Design Review Committee Meeting

Ms. Ardina Pierre has submitted an application seeking approval to demolish the existing home and reconstruct a new 2,622-square foot single-family dwelling with a detached garage at 817 Custer Street. The property is zoned V, Village and located within the Arts District Overlay.

**DEPARTMENT OF PLANNING AND ZONING
PLANNER'S REPORT**

DATE: September 3, 2020
TO: Tonya Hutson
FROM: Lynn Patterson
RE: **Design Review – 817 Custer St Revised**

NEW SOUTHEAST (FRONT) ELEVATION

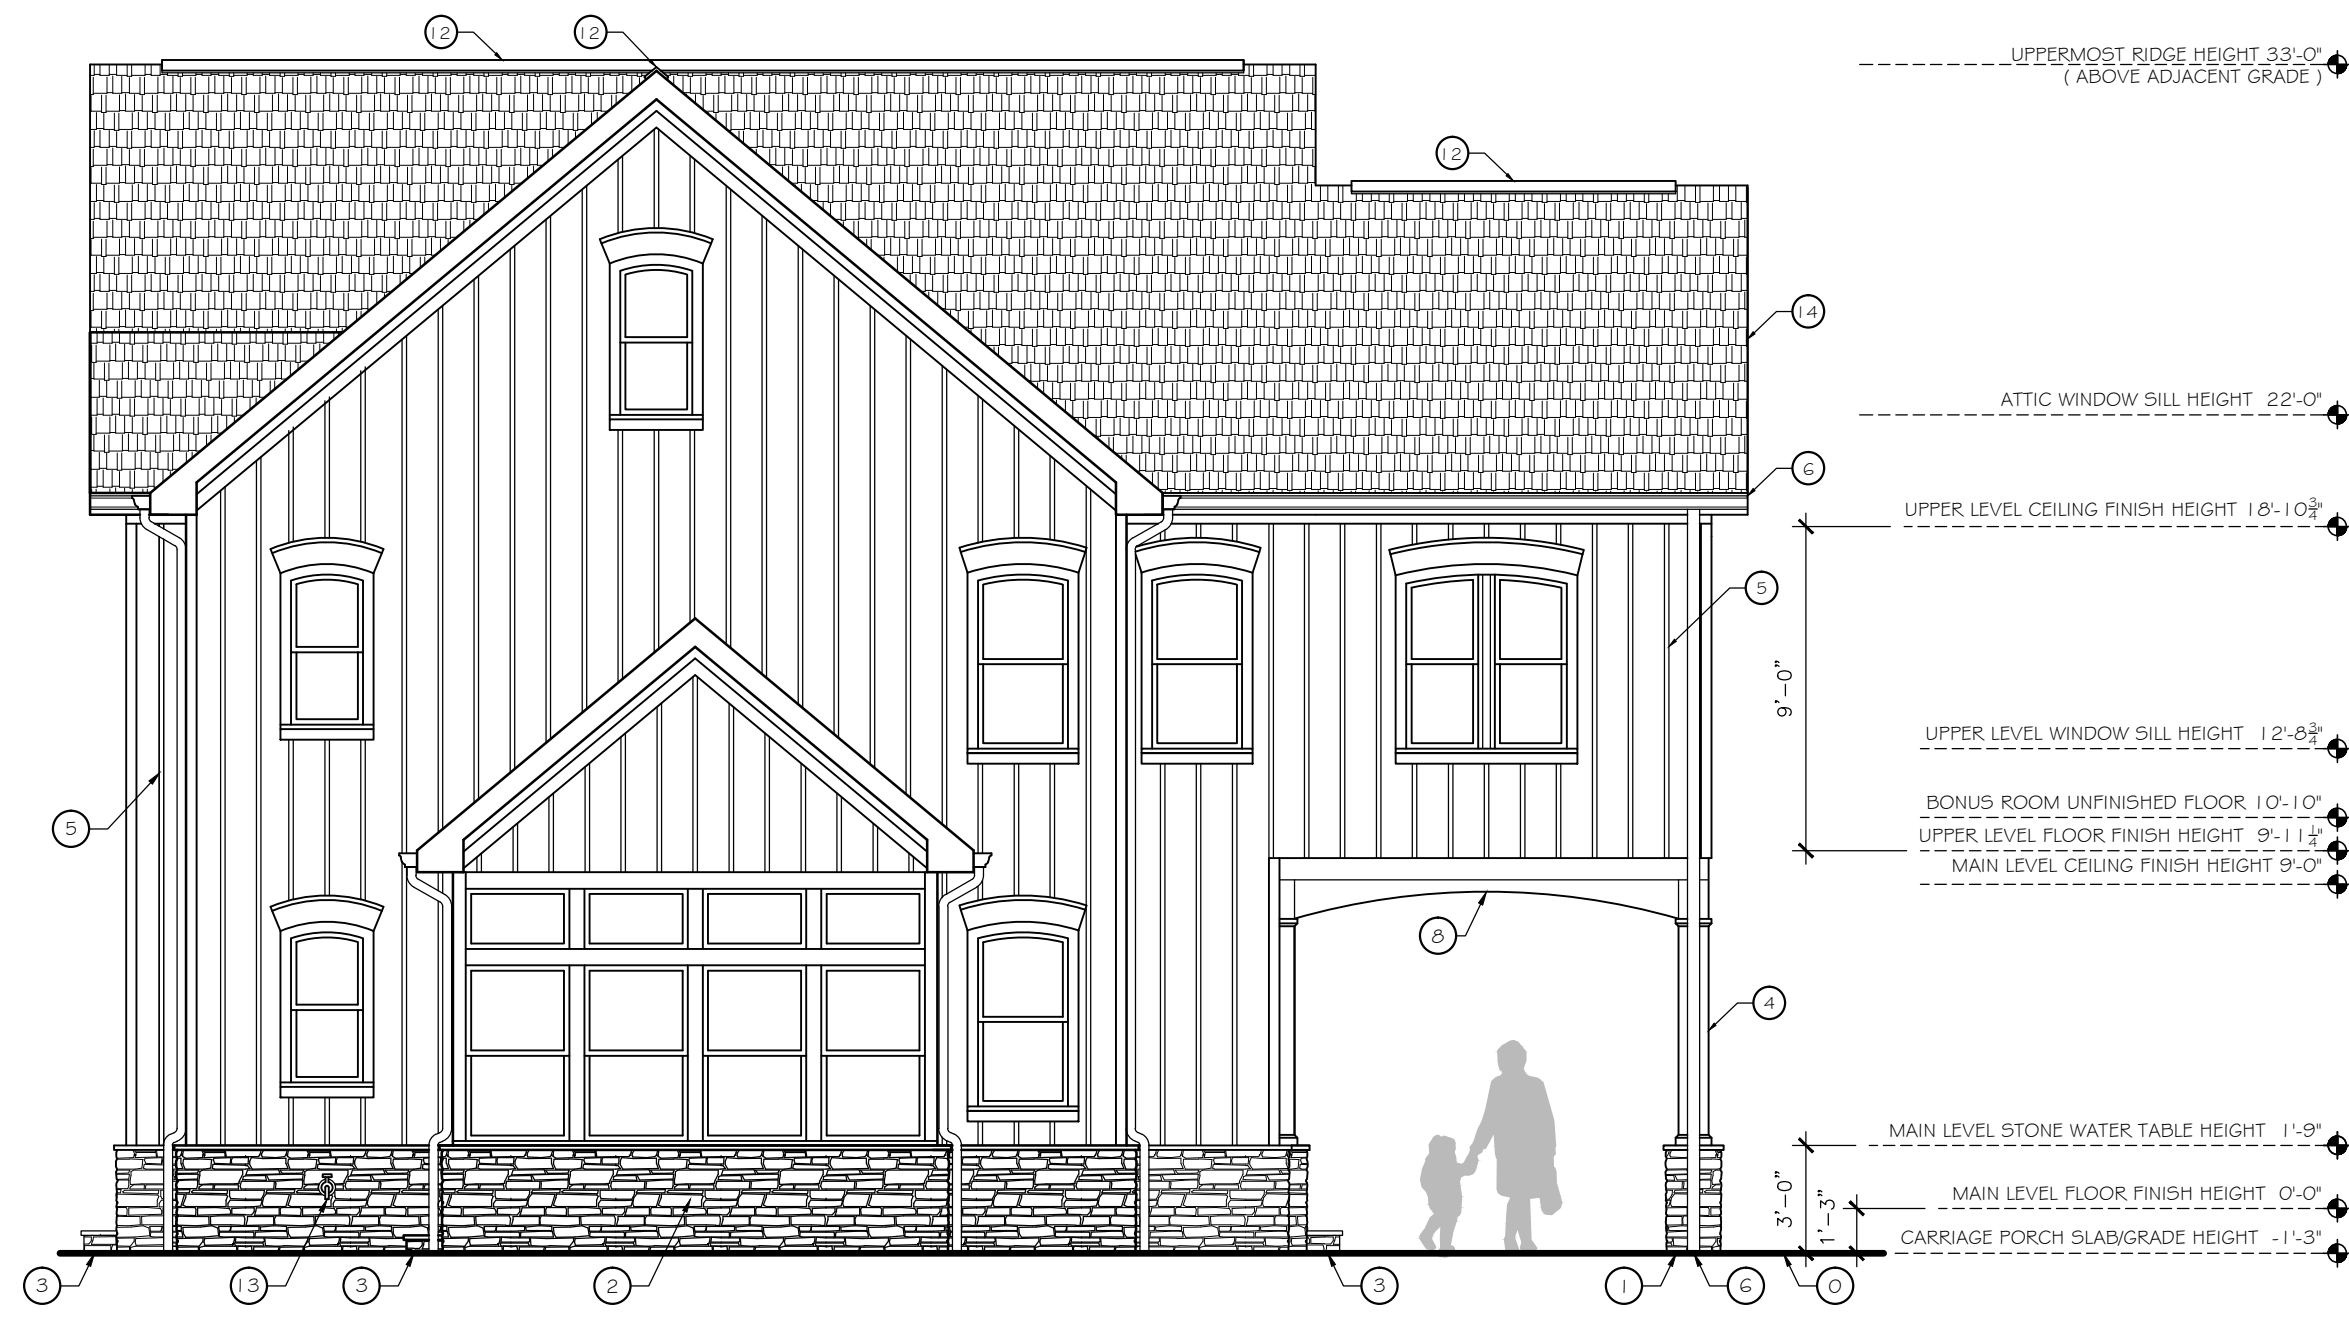
Column detail should be provided. Provided.

Provide detail for railing to ensure meets standards. Provided

Provide porch and balcony dimensions. Provided

- Column detail should be provided. **Provided.**
- Specify gutter and downspout material. **Provided**
- Ensure that overhangs meet a minimum of 12 inches beyond the façade. **Provided**

- Ensure that chimneys extend between 3 – 6 feet above the roof line. **Chimney removed.**
- **All wood must be painted or stained**
- Provide detail for railing to ensure meets standards. **Provided**

- Provide porch and balcony dimensions to ensure porch depth meets the 8' standard. **Porch meets standard.**

2 WINDOW ELEVATIONS
SCALE: 3/8" = 1'-0"

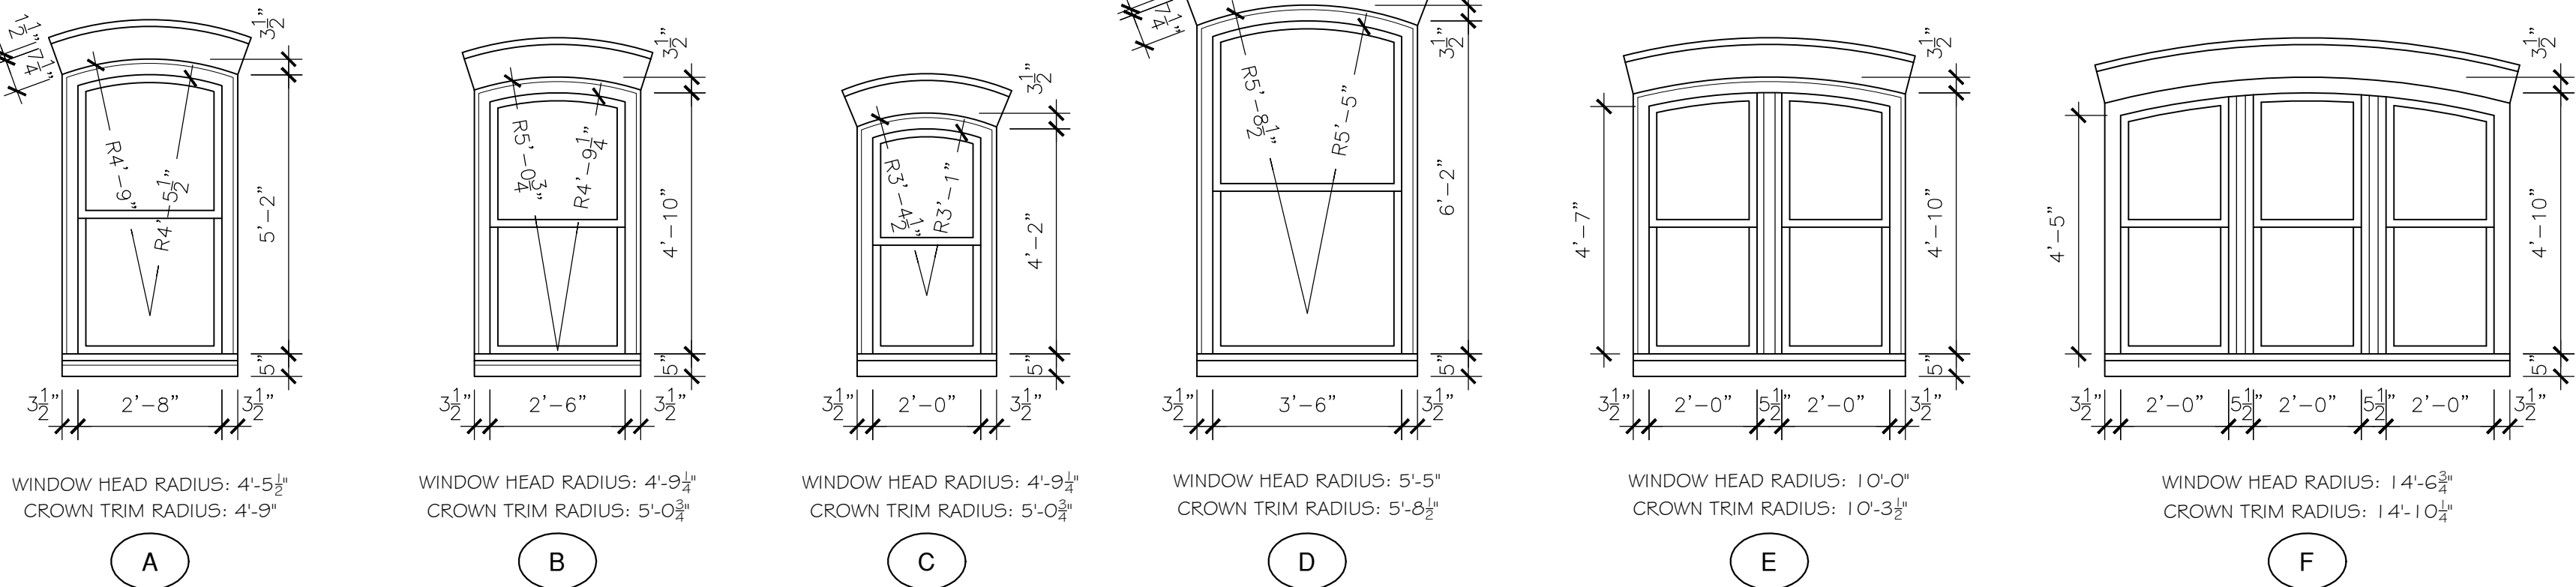
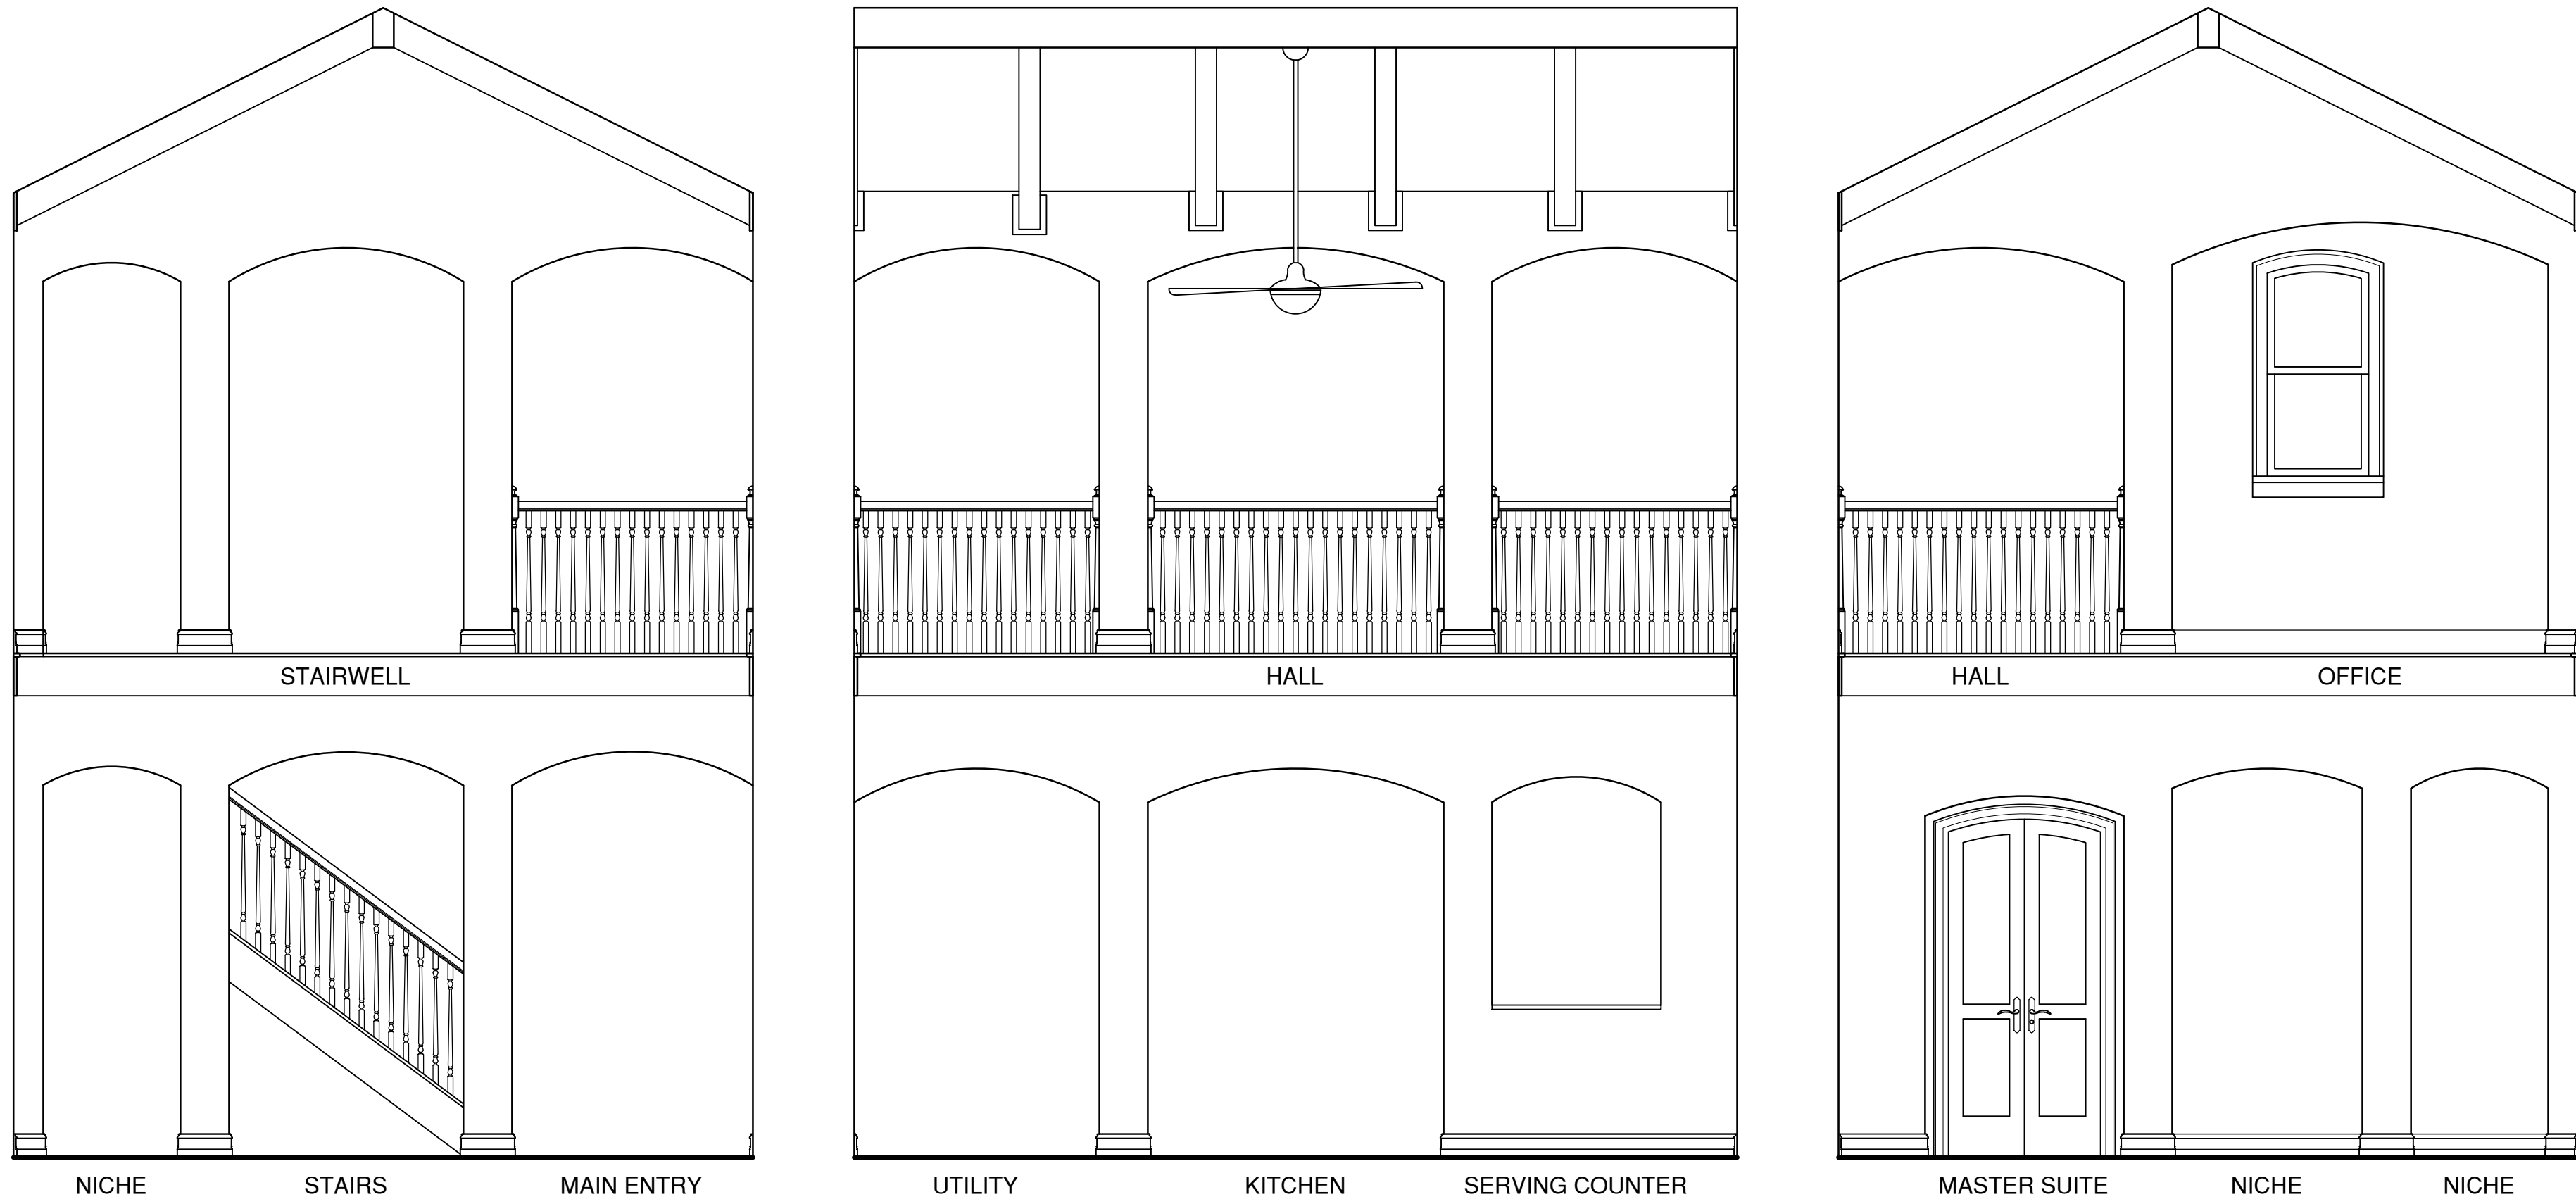
Provide window dimensions to ensure that the window and door standards are being met, including recess. Provided

Provide trim dimensions to ensure standards are met. Provided

Provide sill information Provided

Provide dimensions for sills above finished floor elevation.

- Ensure that each column is spaced a maximum of 8 feet from the center **Provided**
- Buildings numbers must be provided **Provided**
- Provide window dimensions to ensure that the window and door standards are being met, including recess. **Provided**
- Provide trim dimensions to ensure standards are met. Center mullions should be 2" wider than trim. **Provided**
- Provide sill information **Provided**
- Provide dimensions for sills above finished floor elevation. **Provided**
- Ensure that the garage is not within 10' of neighboring shed. **Provided**
